Addendum No.3
to
CONSTRUCTION DOCUMENTS
for

NCISD New District Administration Building
21330 Valley Ranch Parkway
New Caney, TX. 77357
June 2, 2025

Below is a summary of the sheet and specification revisions for Addendum #3.

E-212-C2

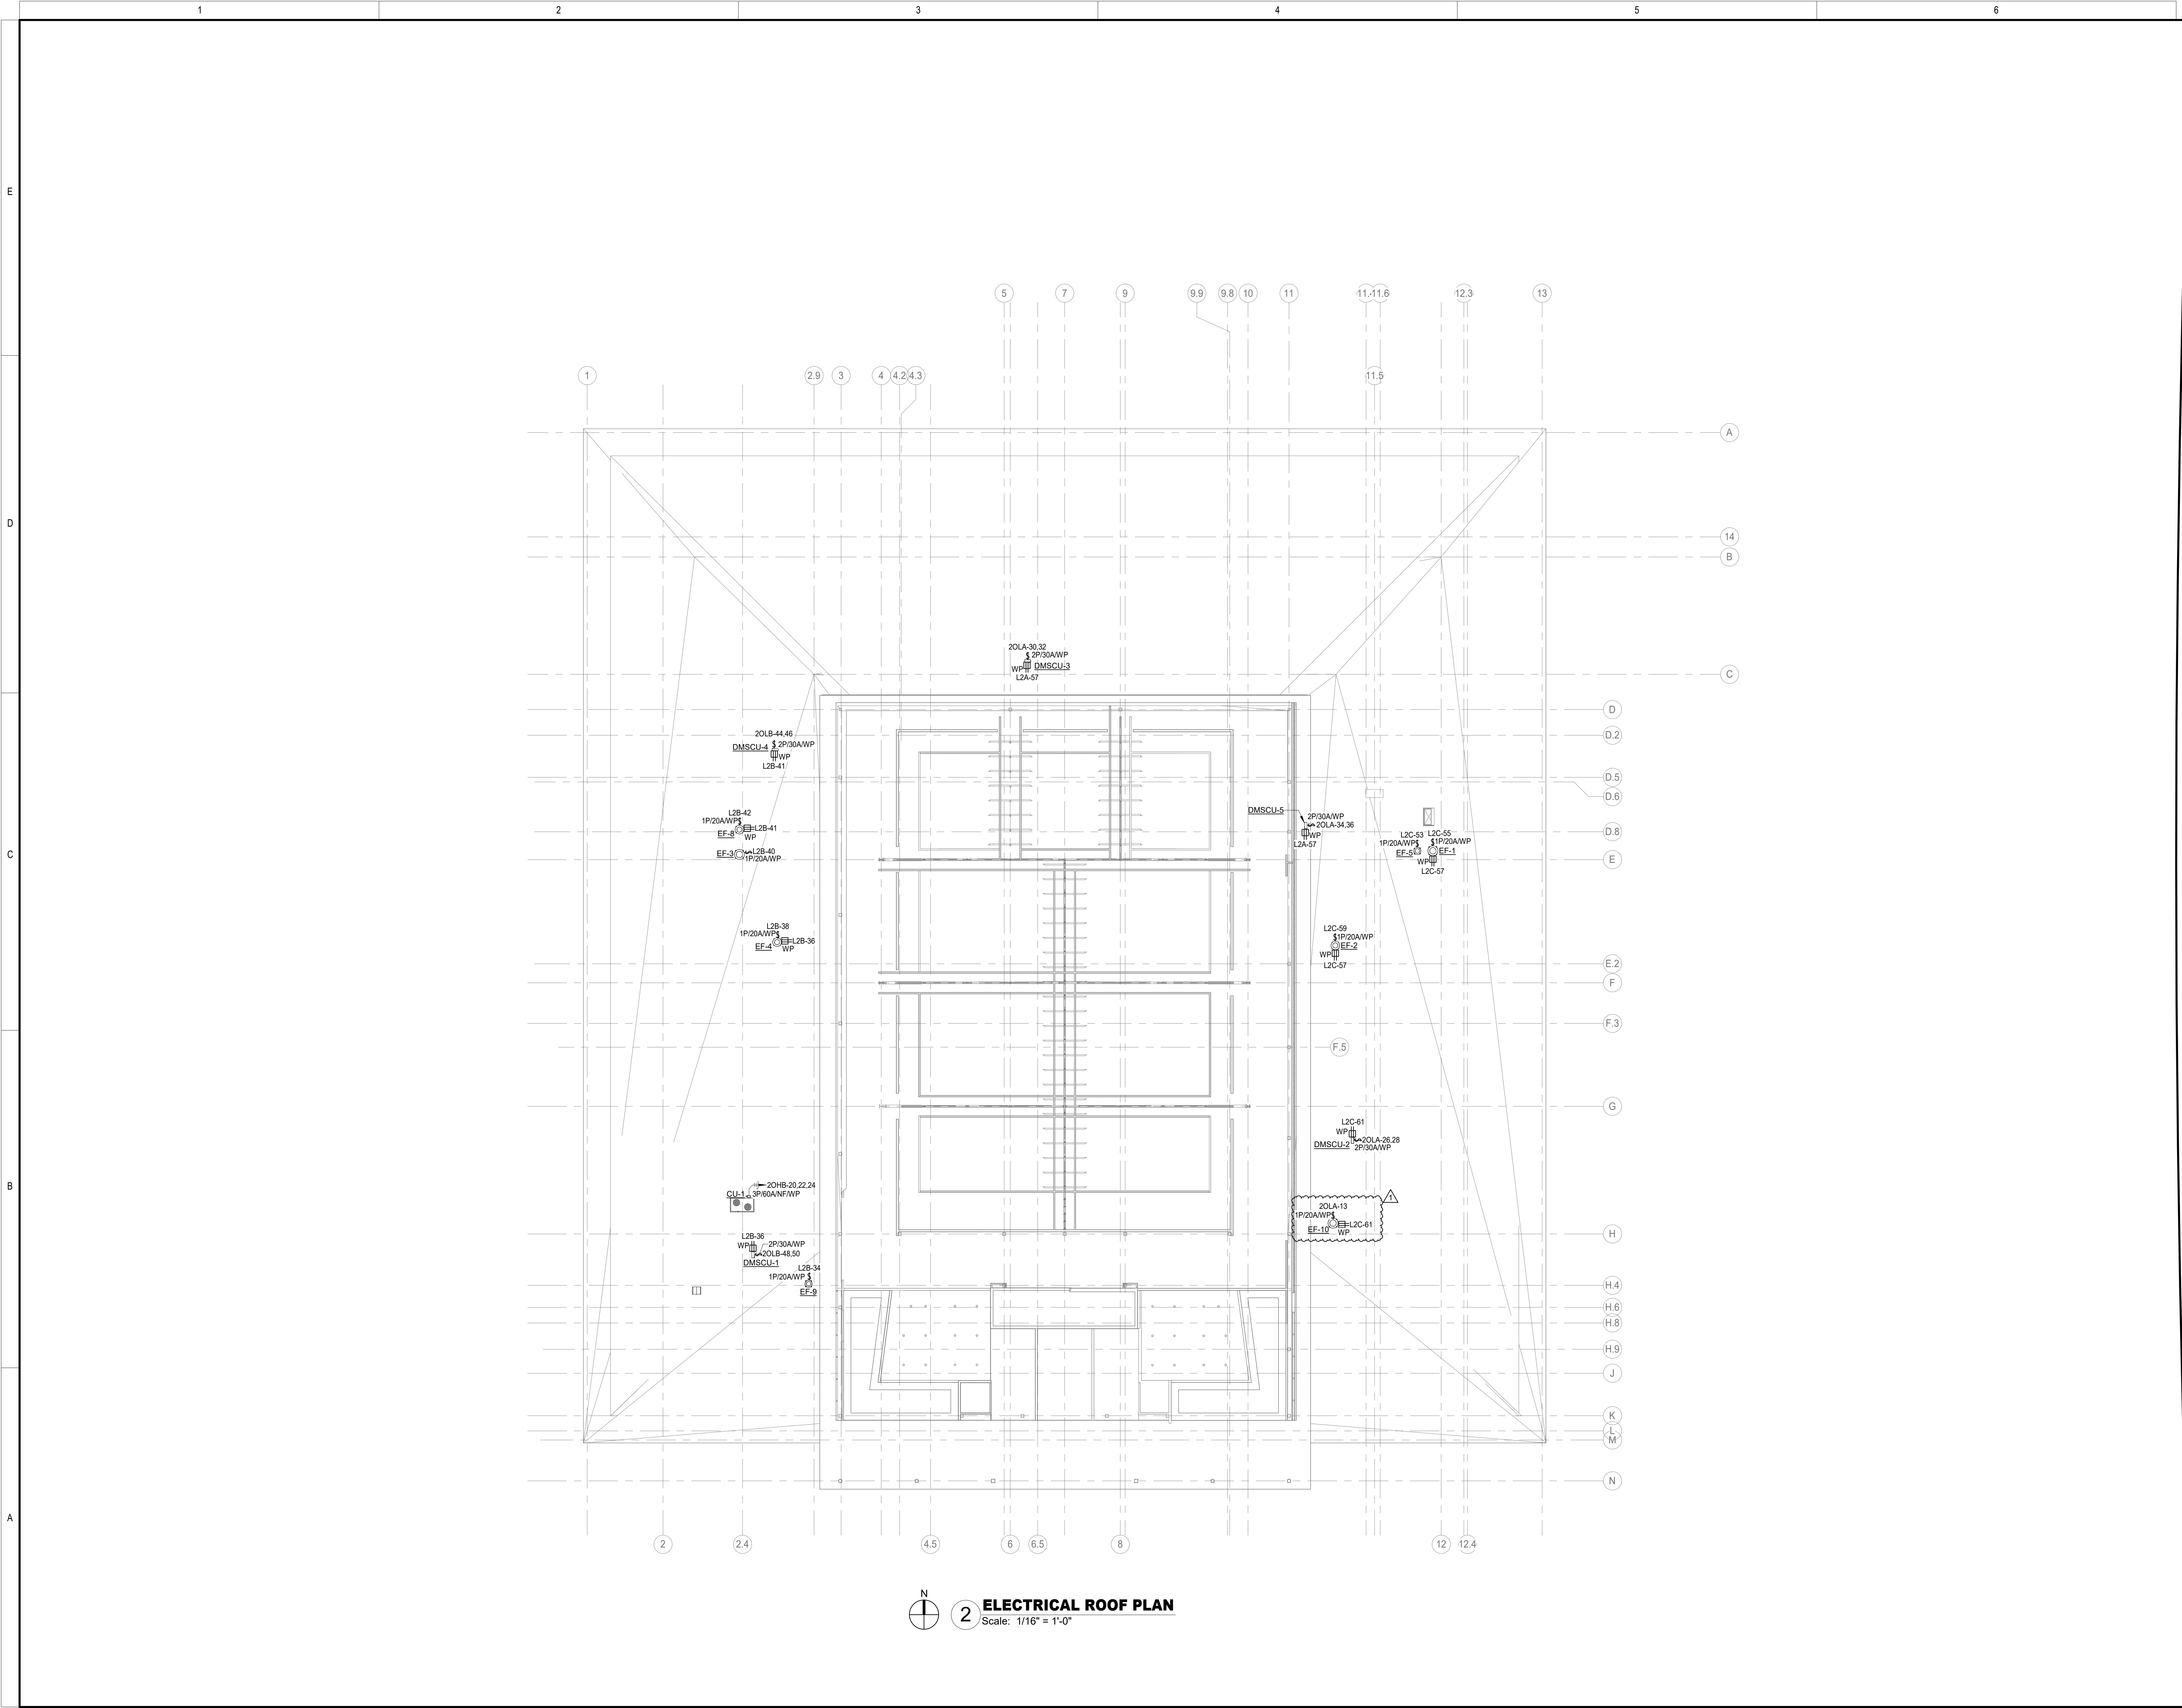
- a. Add Duct Attenuators schedule.
 - b. Revise Air Handling Unit Schedule.
 - c. Revise Variable Volume Terminal Unit Schedule.
10. SHEET E-212-C2 ELECTRICAL POWER SECOND FLOOR AREA = C2

- a. Add 45 kva transformer T2OLB in Mech C215.
11. SHEET E-218 – ELECTRICAL ROOF PLAN
 - a. Update electrical due to new location of EF-10.
12. SHEET E-401 – ELECTRICAL ONE-LINE DIAGRAM

M-113-D2

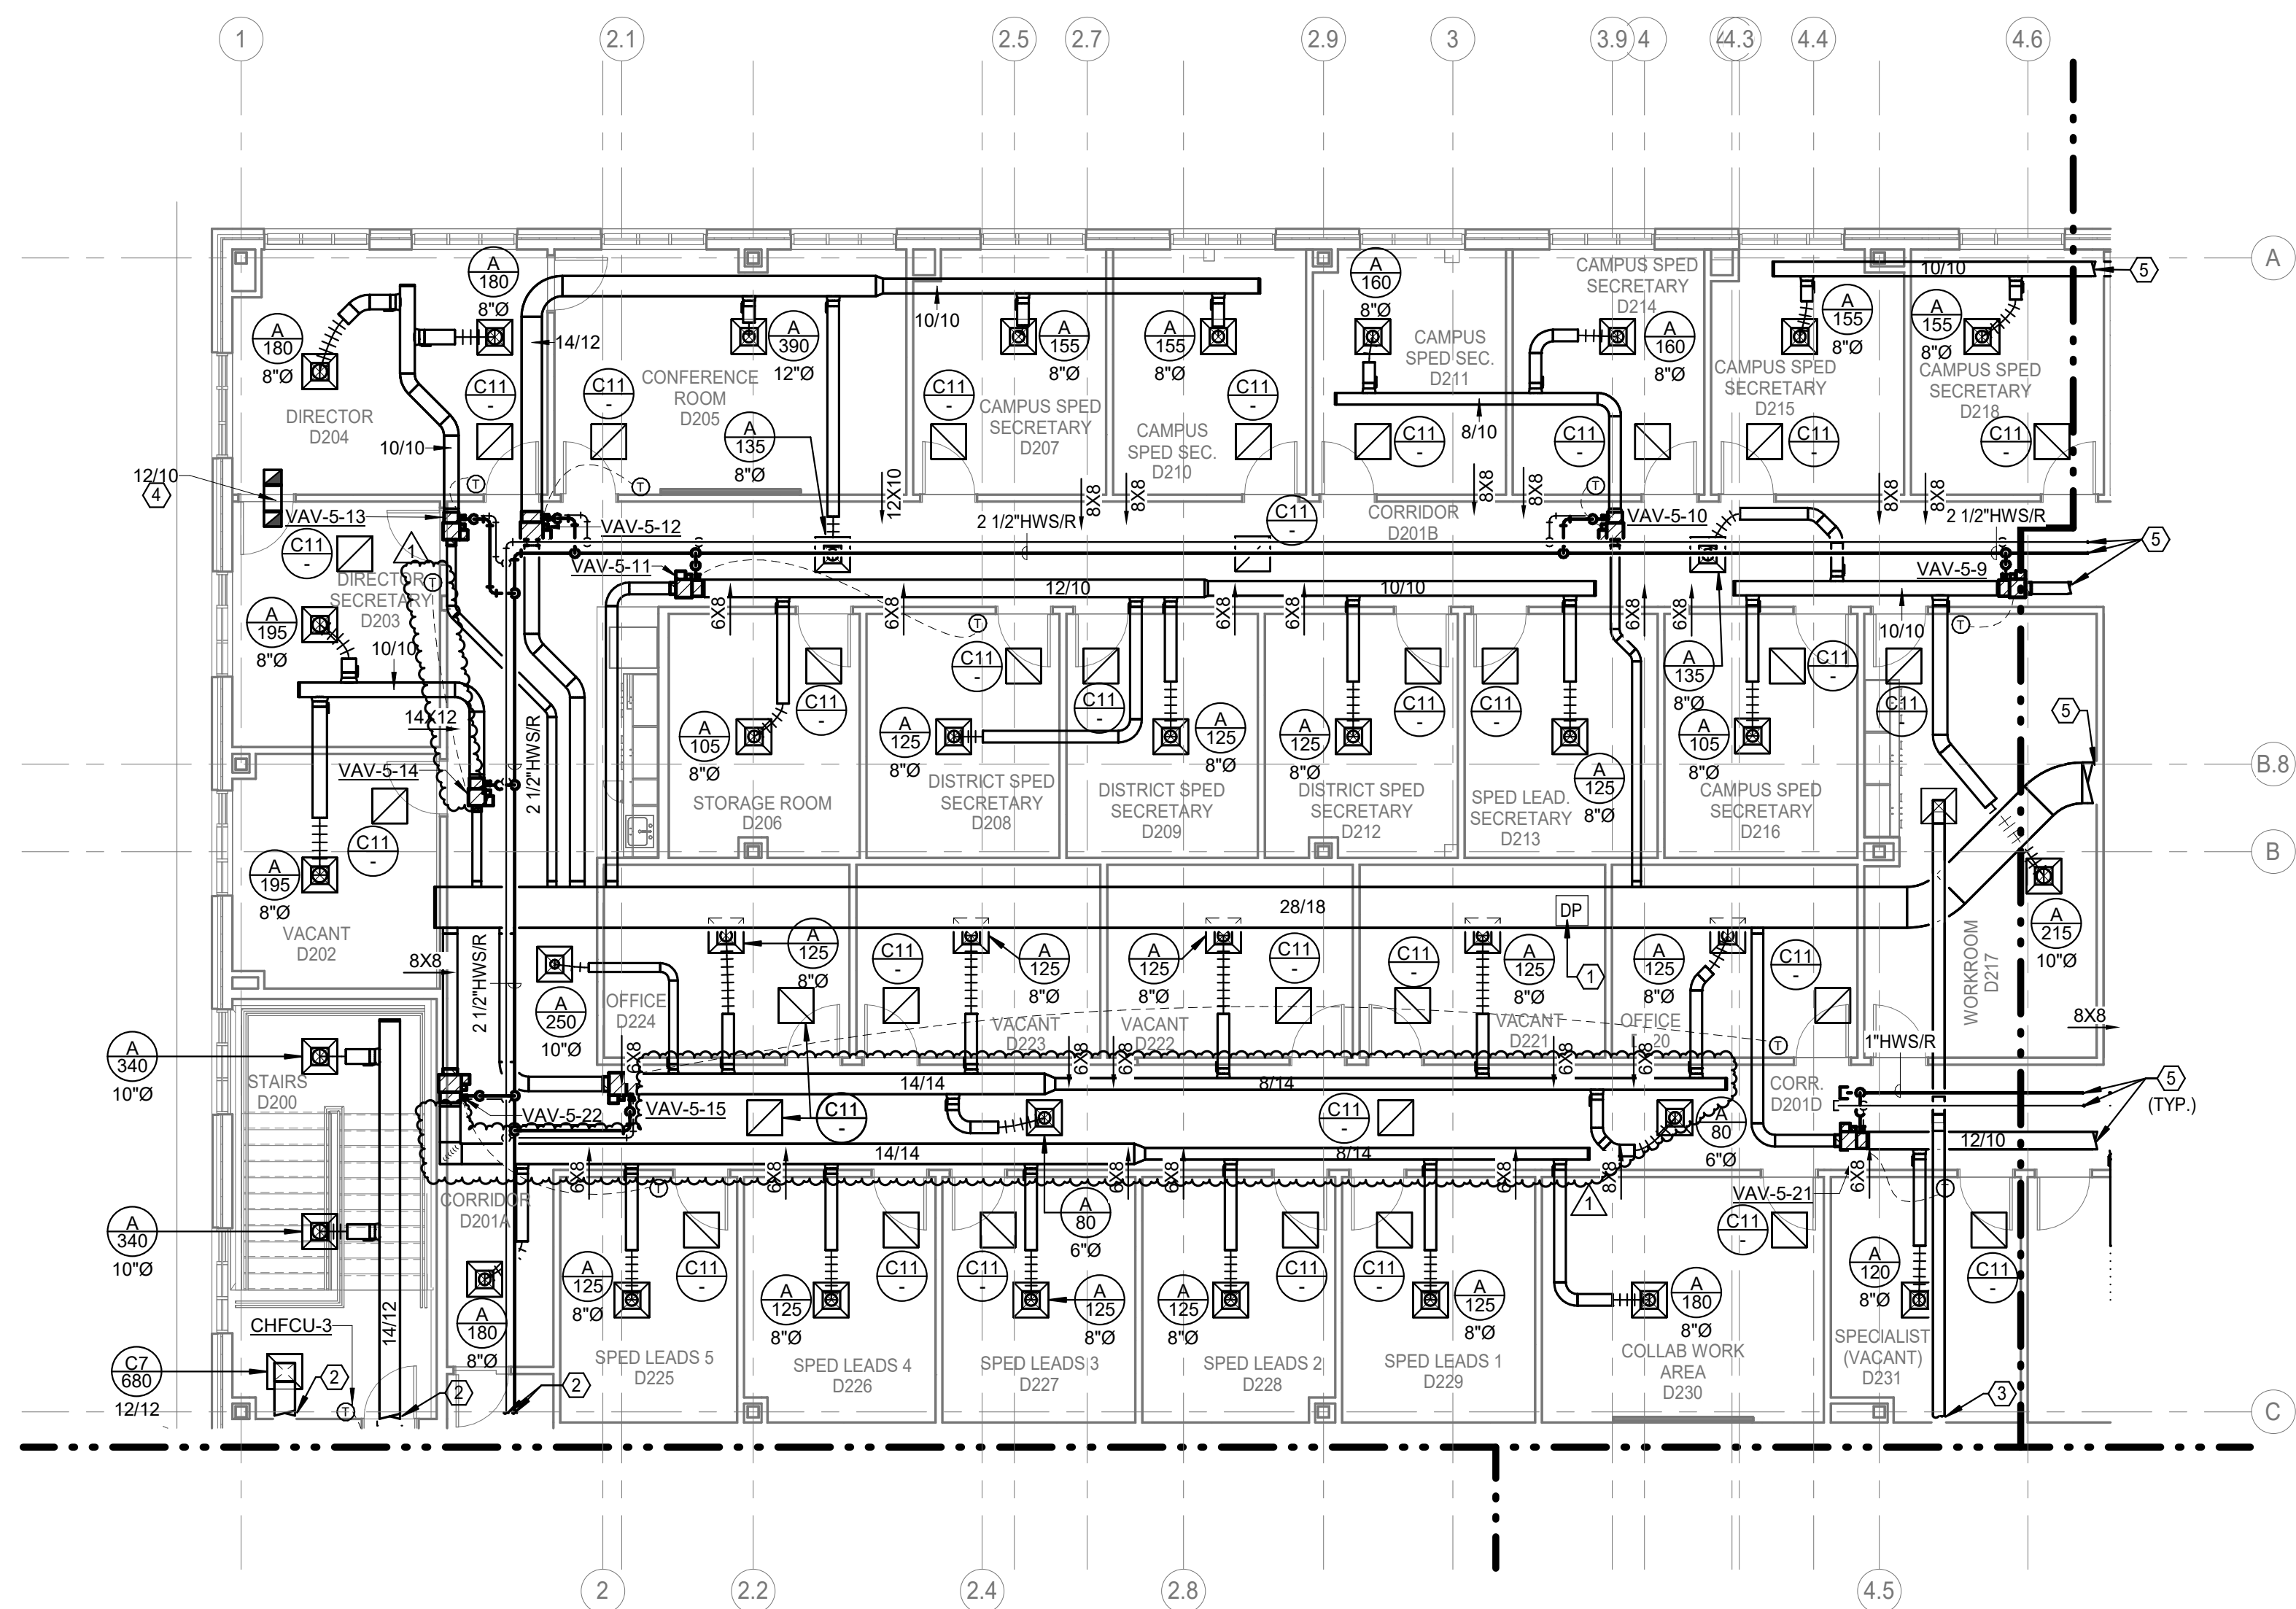
1. SHEET M-104-C1 – MECHANICAL FIRST FLOOR AREA – C1
 - a. Revise medium pressure supply ductwork, low pressure supply ductwork and return air transfer boot. Refer to sheet.
2. SHEET M-113-D2 – MECHANICAL SECOND FLOOR AREA – D2

- a. Revise location of temperature sensor for terminal unit VAV-5-14 to be located in Director Secretary D203.
- b. Revise low pressure ductwork to terminal boxes VAV-5-15 and VAV-5-22.

M-115-E2

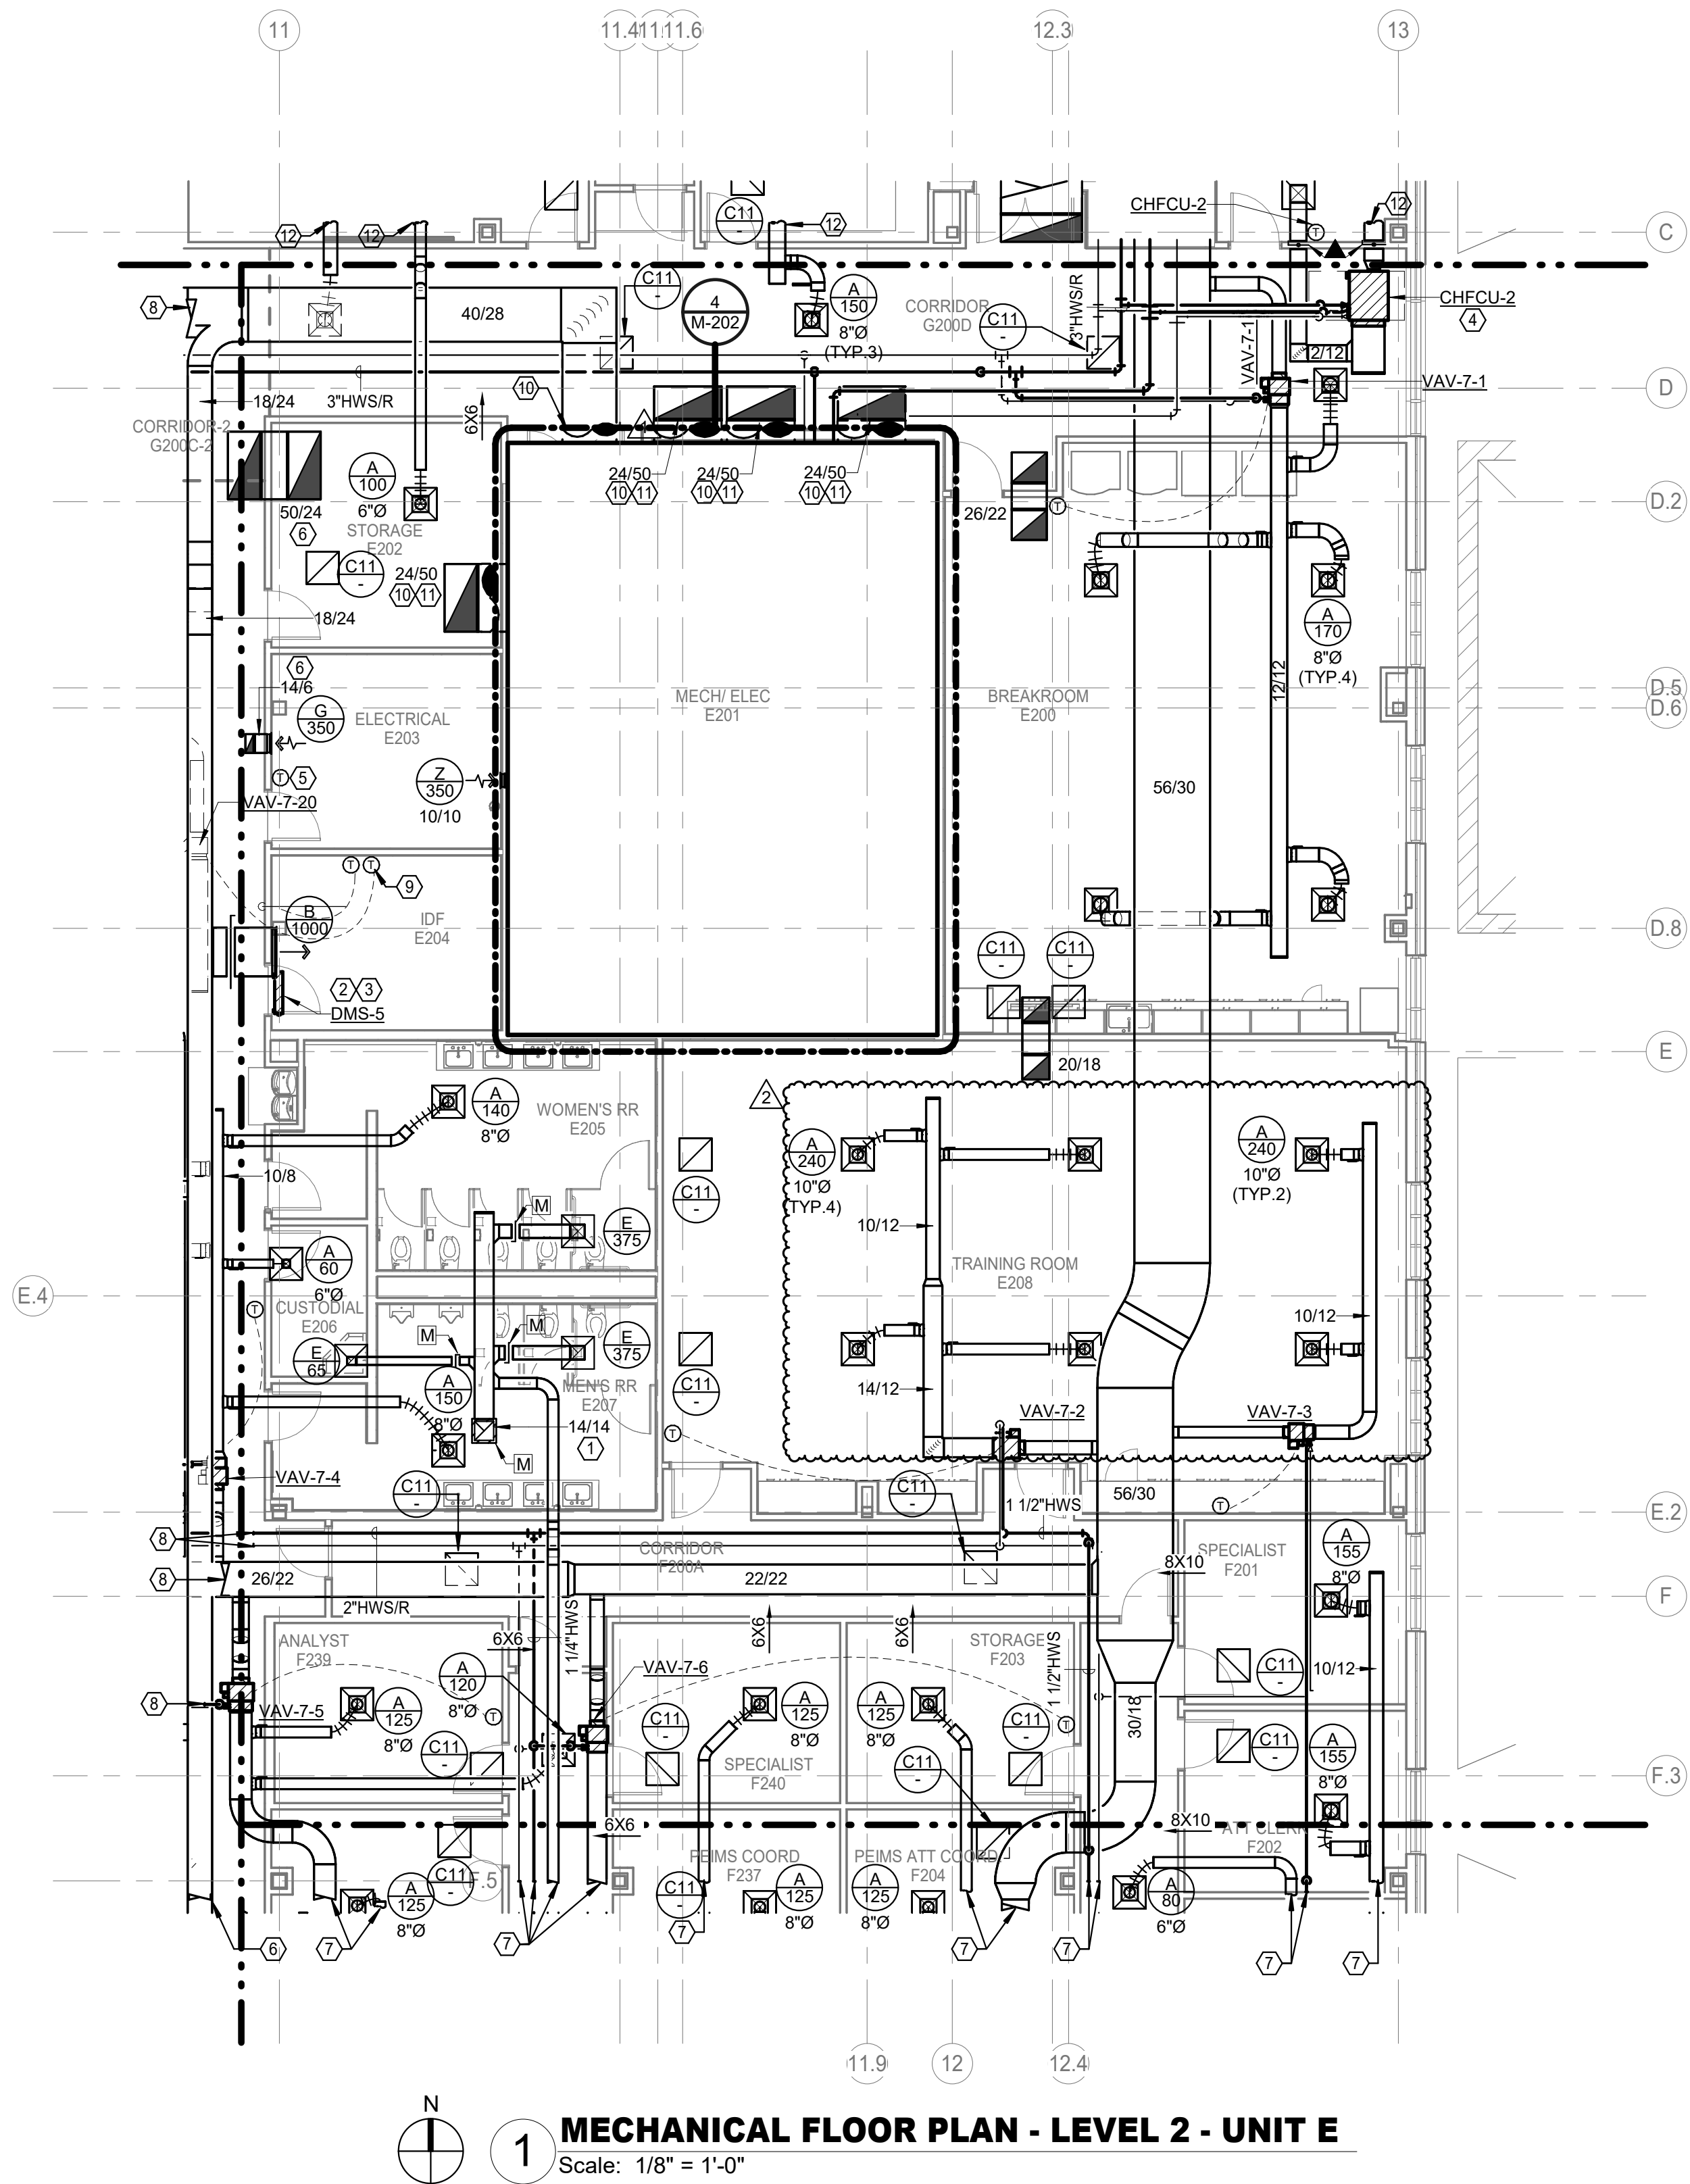
3. SHEET M-114-D2.2 – MECHANICAL SECOND FLOOR AREA – D2.2
 - a. Revise ductwork and grilles serving Video Production Studio D262. Refer to sheet.
4. SHEET M-115-E2 – MECHANICAL SECOND FLOOR AREA – E2

- a. Revise ductwork and grilles serving Training Room E208. Refer to sheet.
5. SHEET M-116-F2 – MECHANICAL SECOND FLOOR AREA – F2
 - a. Revise exhaust ductwork to route above Intern F231. Refer to sheet.
